CLAREMONT BUSINESS PARK 2 FILING NO. 2

CONSTRUCTION PLANS

JUNE 2023

V2_Construction Drawings.pdf Markup Summary

**EL JEFE HEIGHTS
 STA 1+00.00 - 7+95.49**

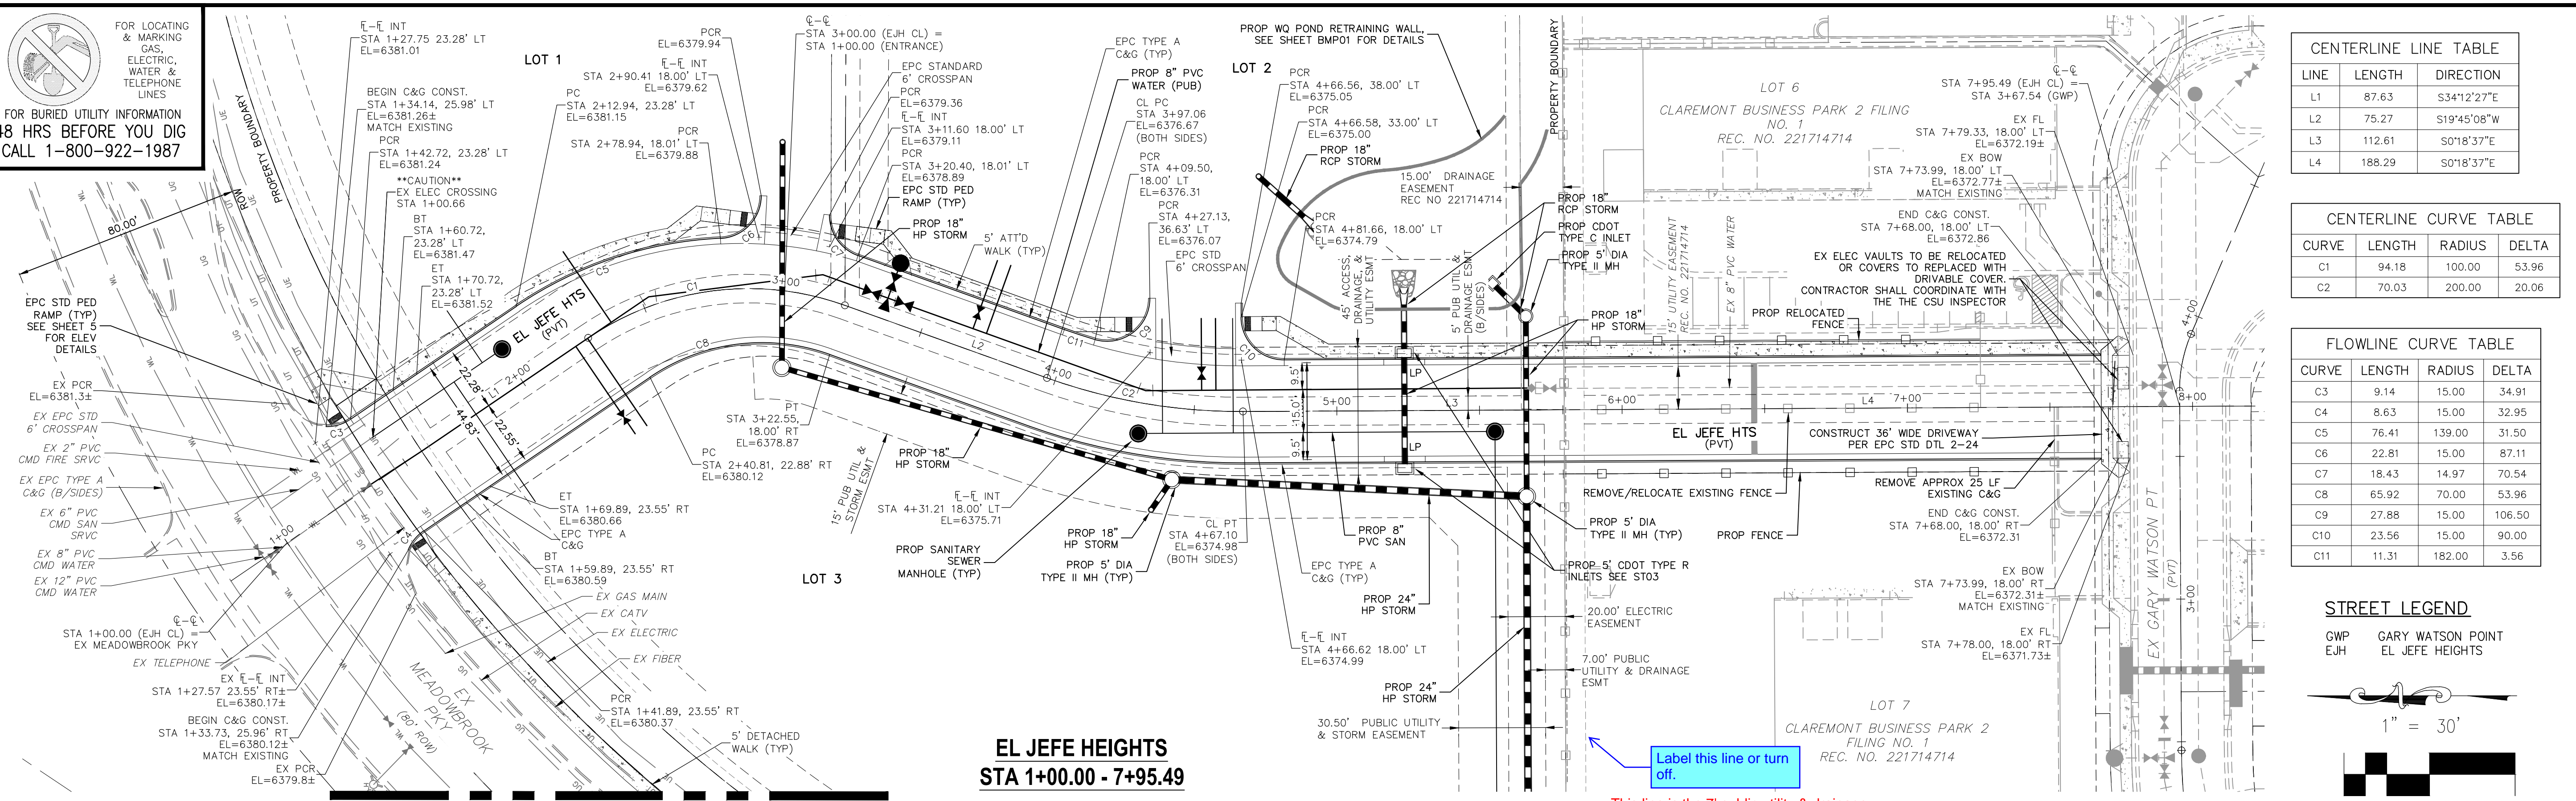
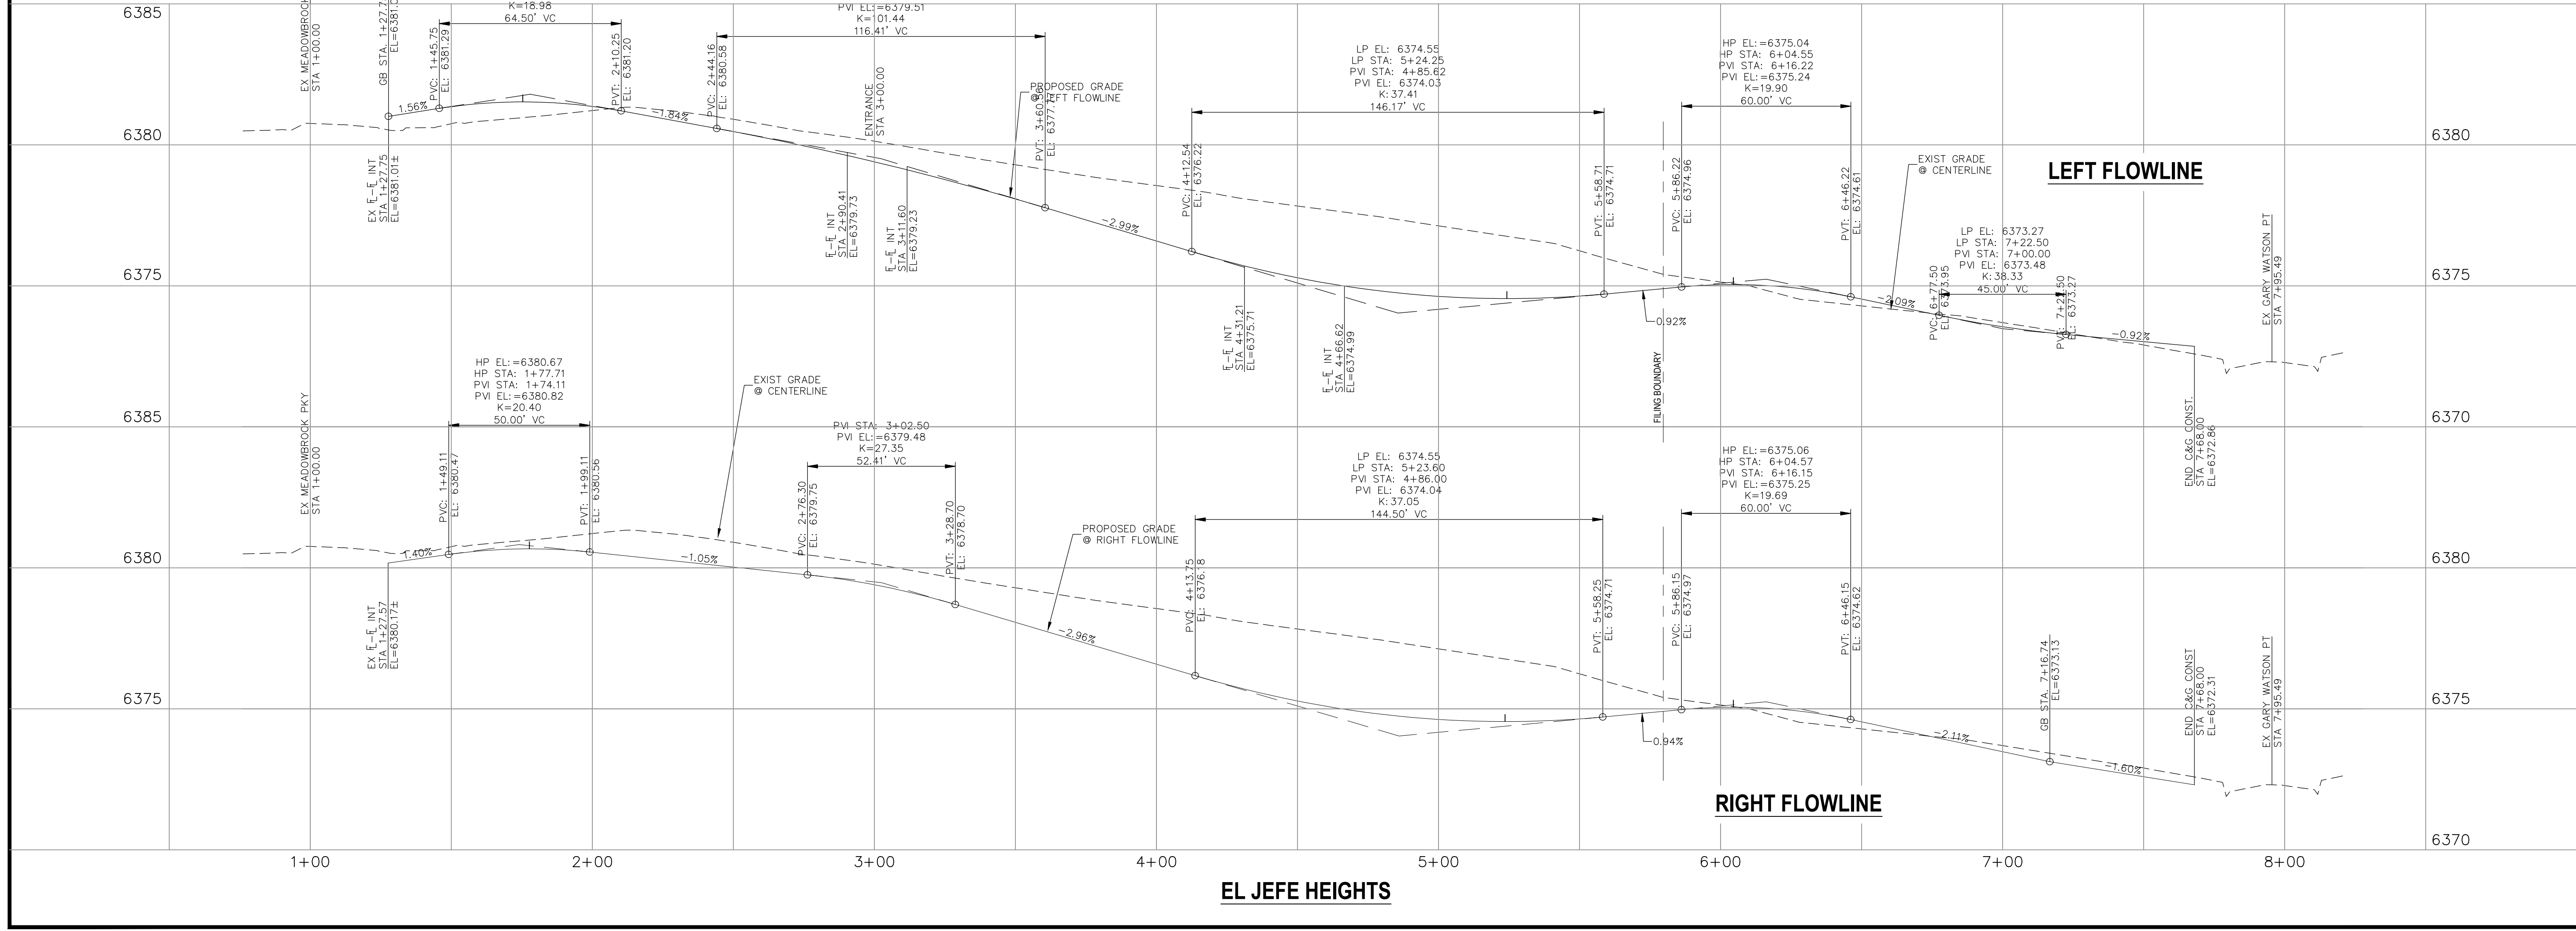
Label this line or turn off.

This line is the 7" public utility & drainage easement on the other side of the property line and has now been labeled.

CLAREMONT BUSINESS PARK 2 FIL. NO. 2
 SIDEWALK & INTERSECTION DETAILS
 PROJECT NO. 10-020
 SCALE: HORIZONTAL: VERTICAL: N/A
 DATE: 06/01/23
 DESIGNED BY: GW
 DRAWN BY: CLP
 CHECKED BY: VAS
 SHEET 5 OF 14
 S102

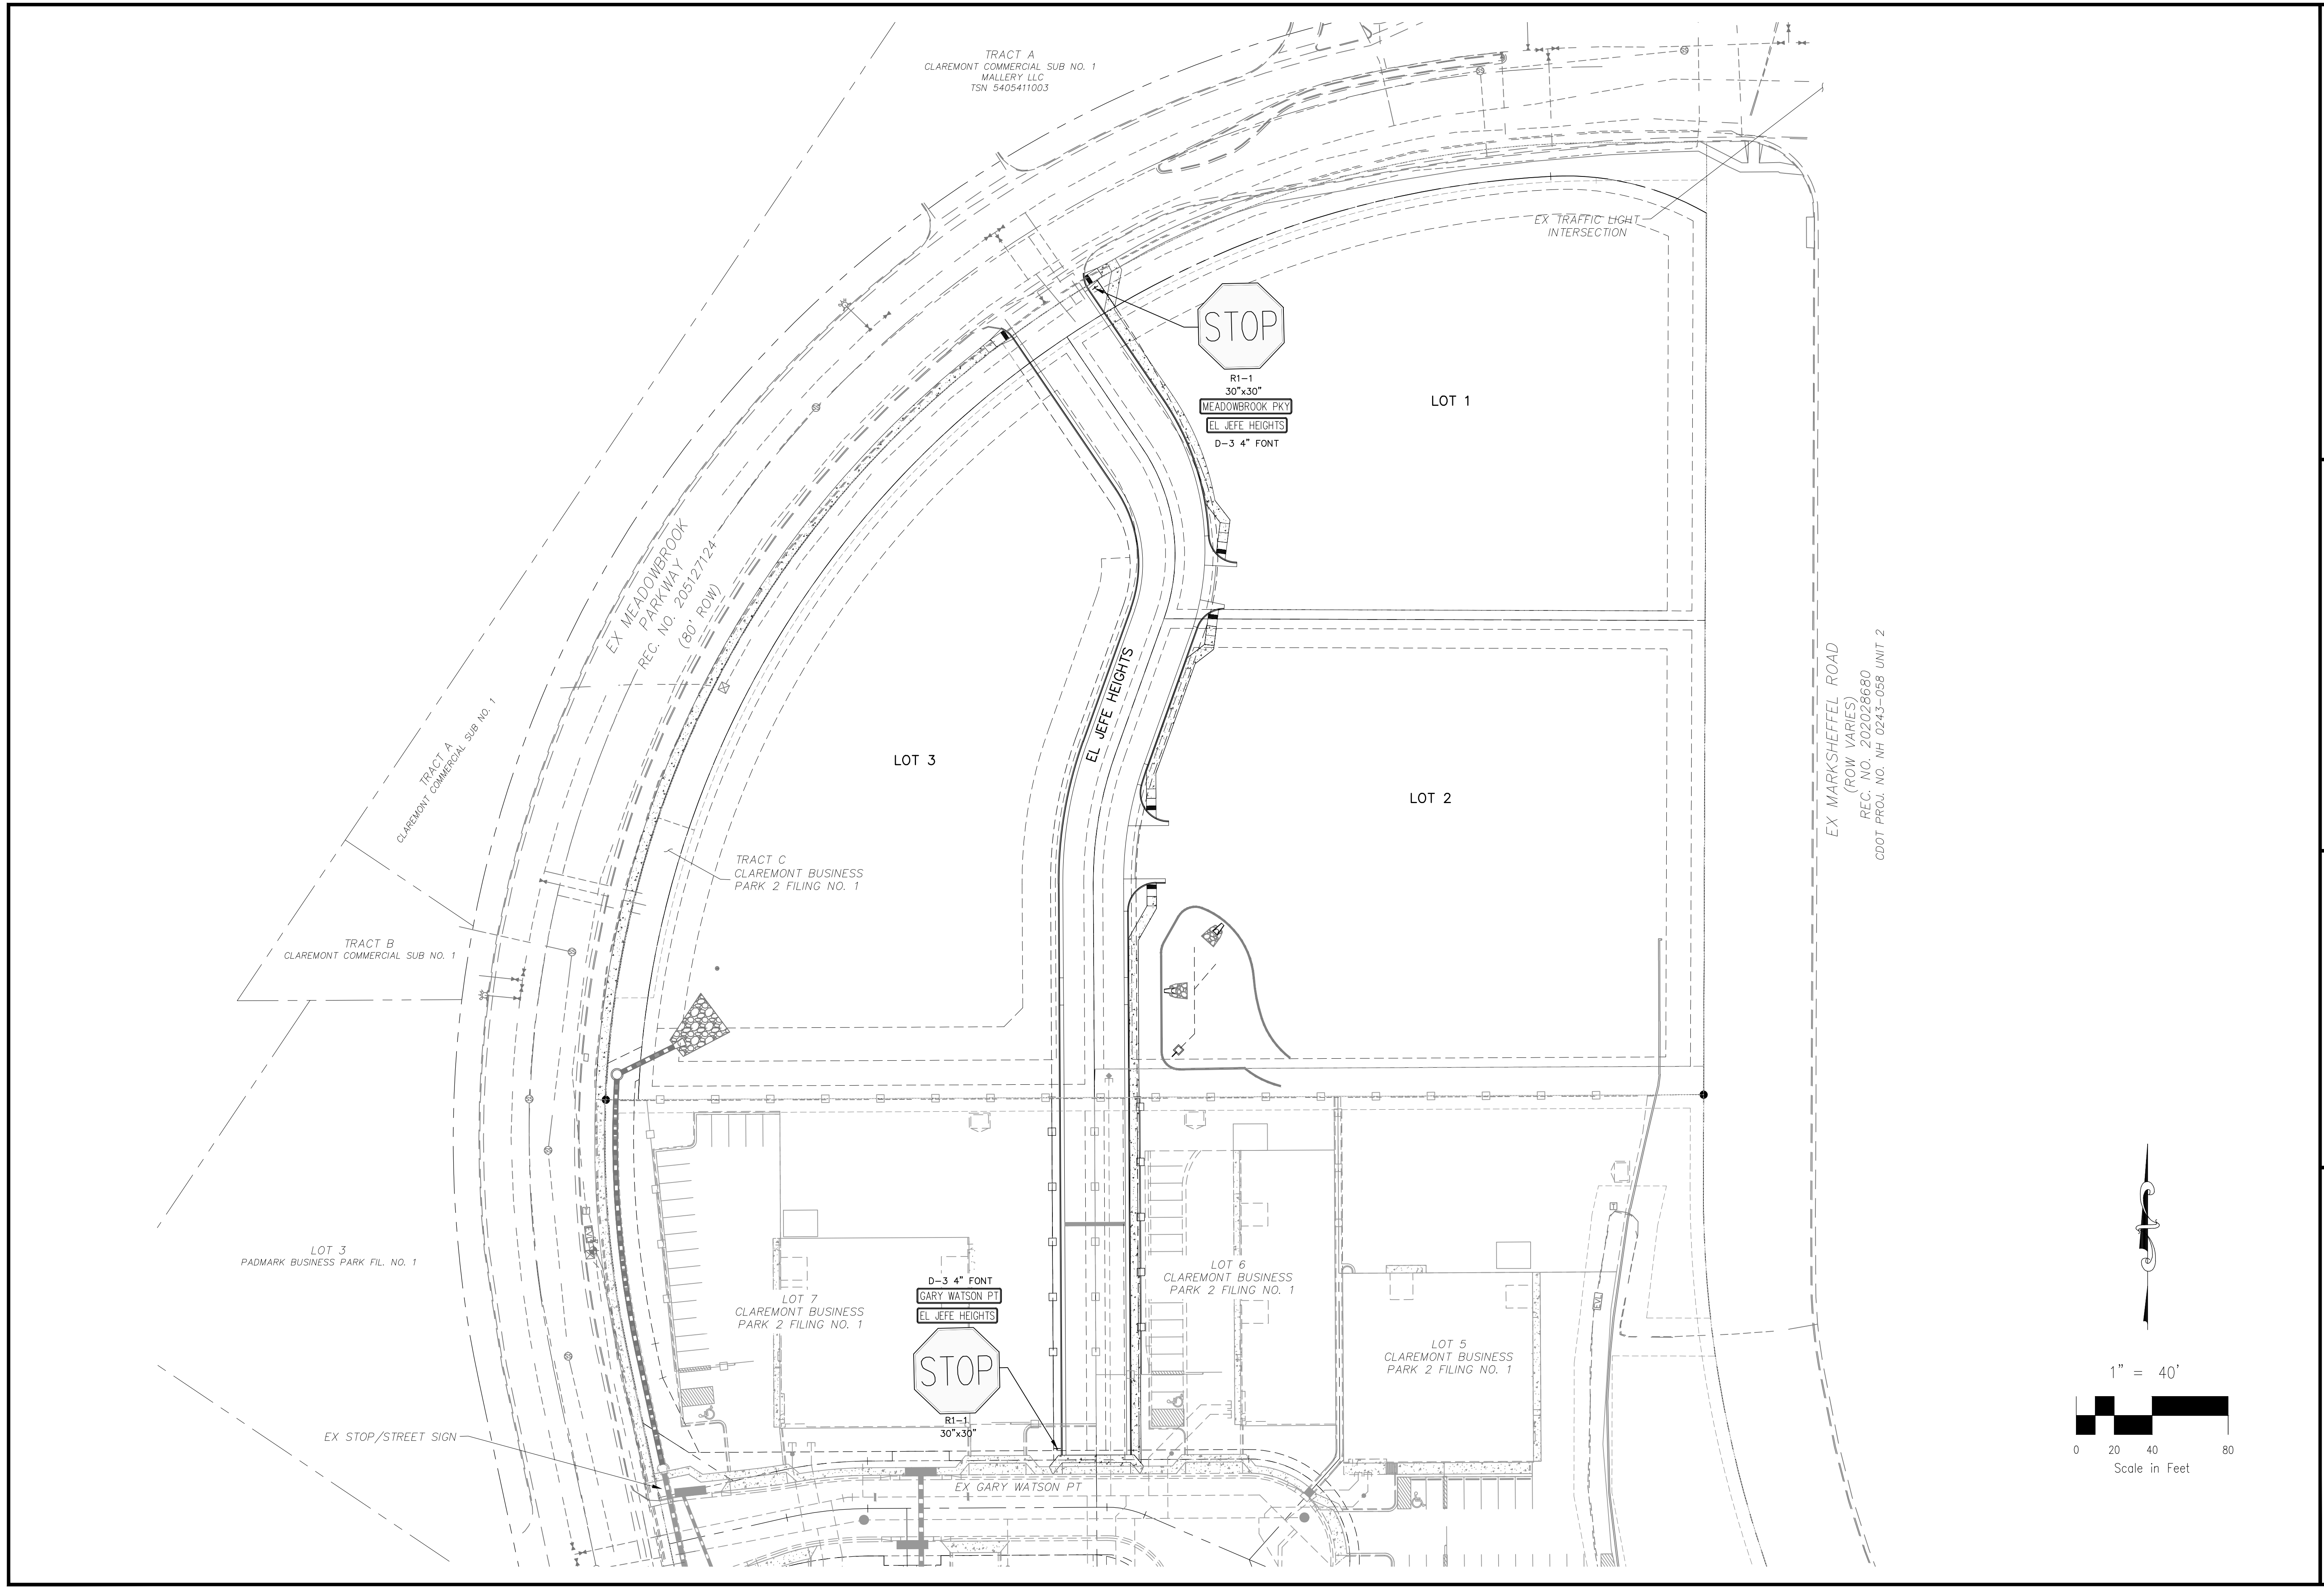
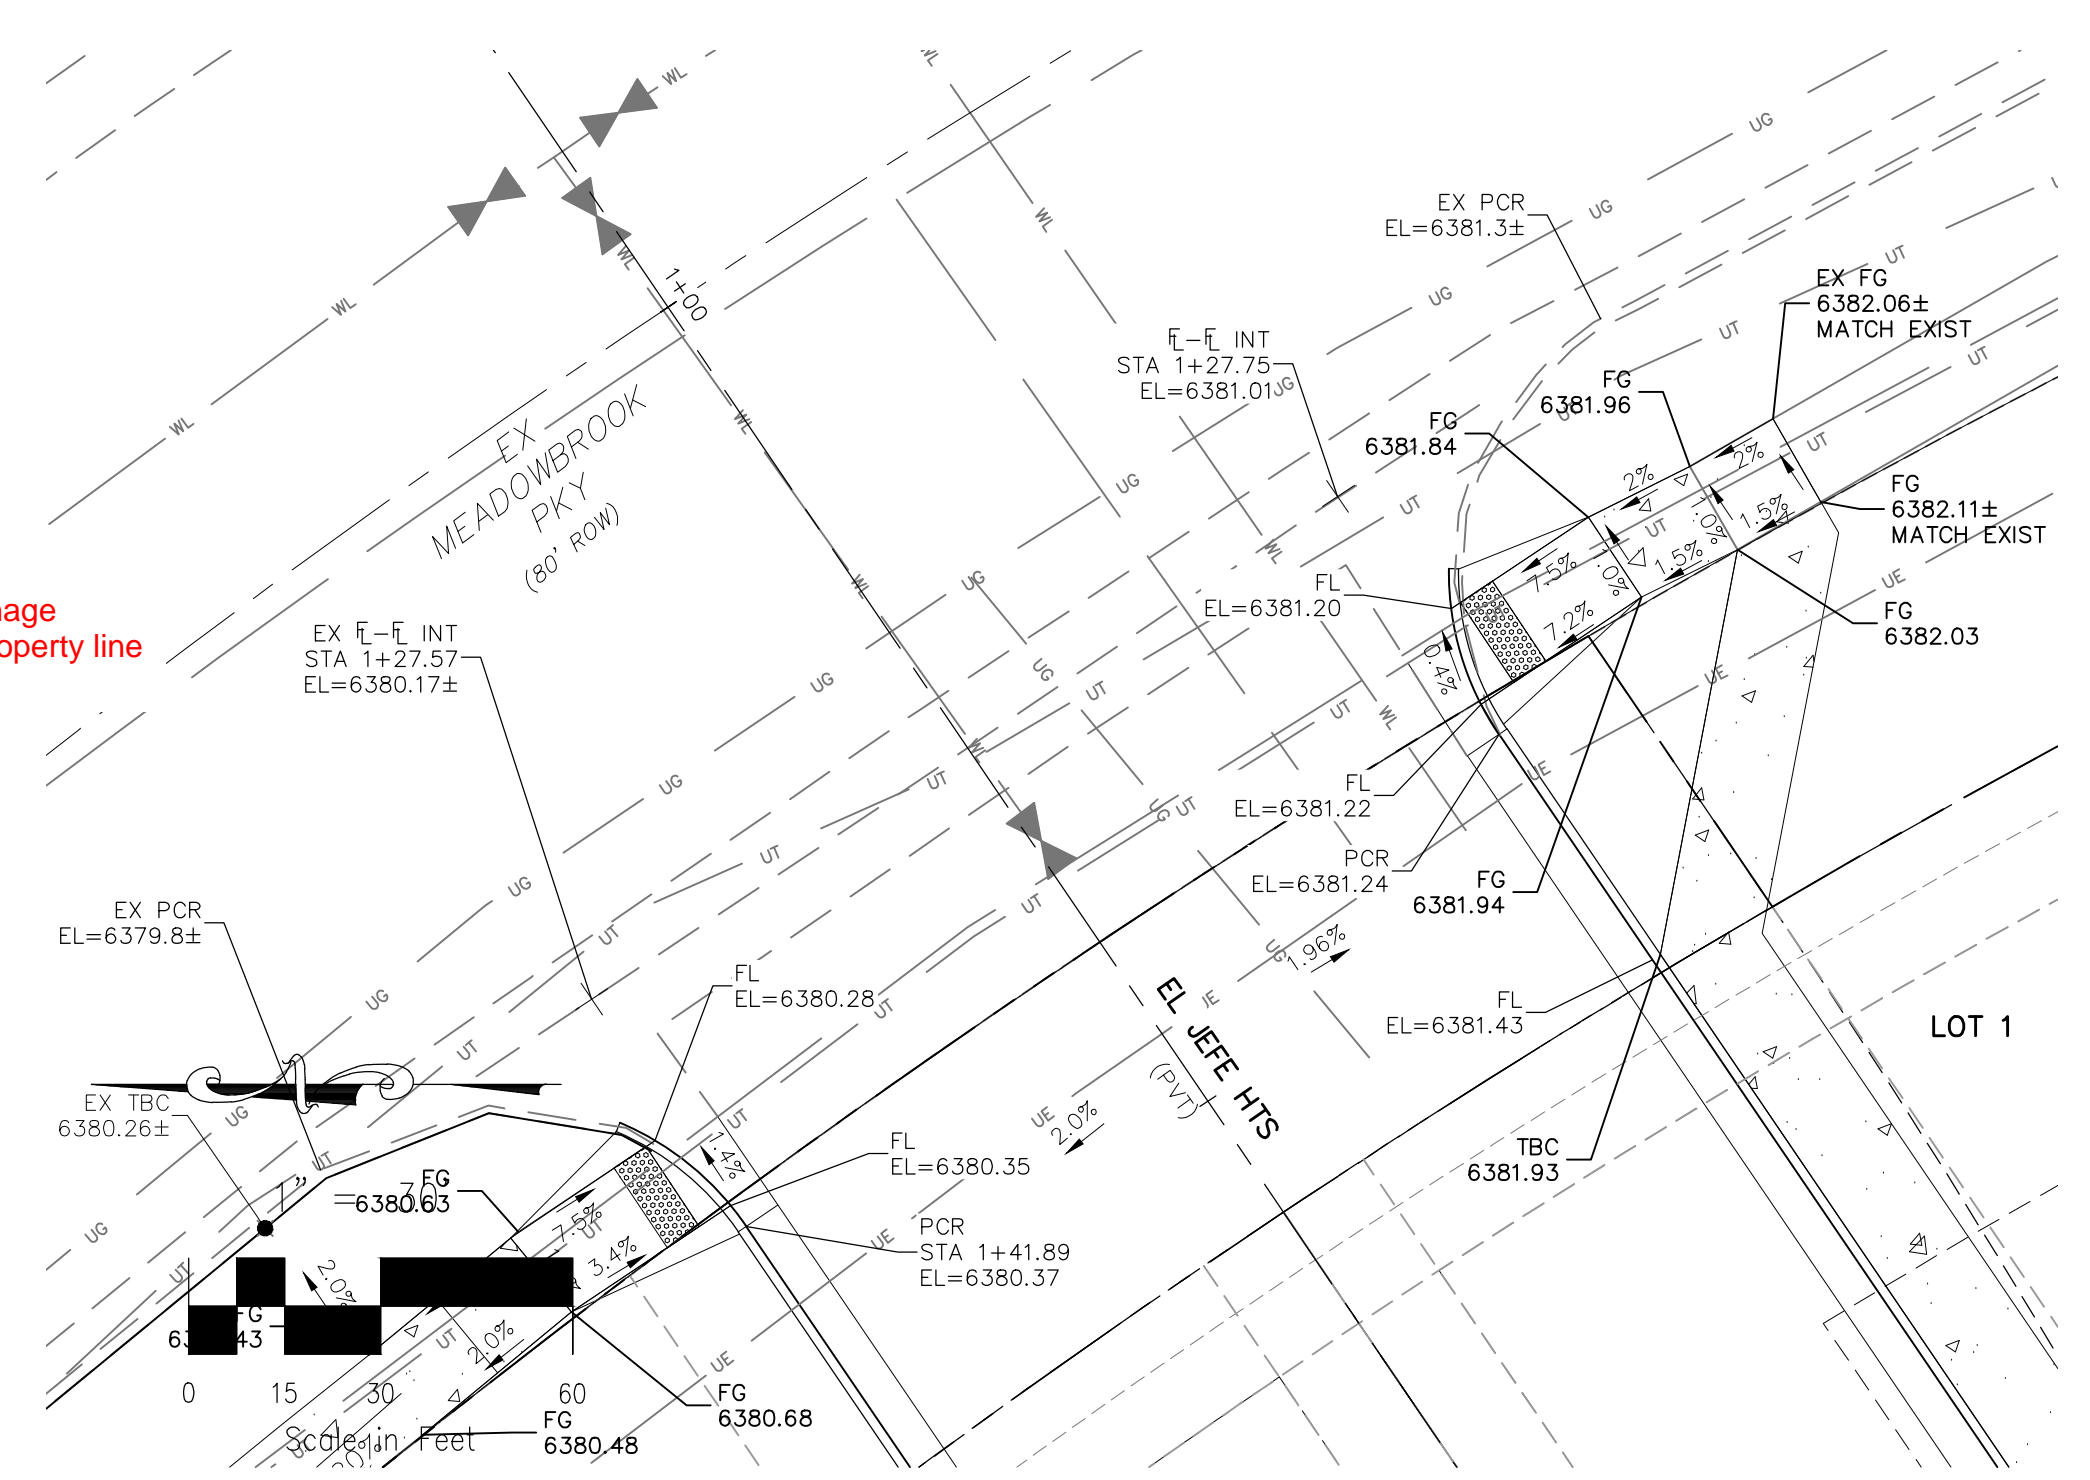
This has been labeled as existing and temporary.
 Label as existing and temporary.
 Label this line or turn off.
 This line is the 7' public utility & drainage easement on the other side of the property line and has now been labeled.

The slope across the cross walk has been added
 Provide slope across El Jefe Hts. through cross walk
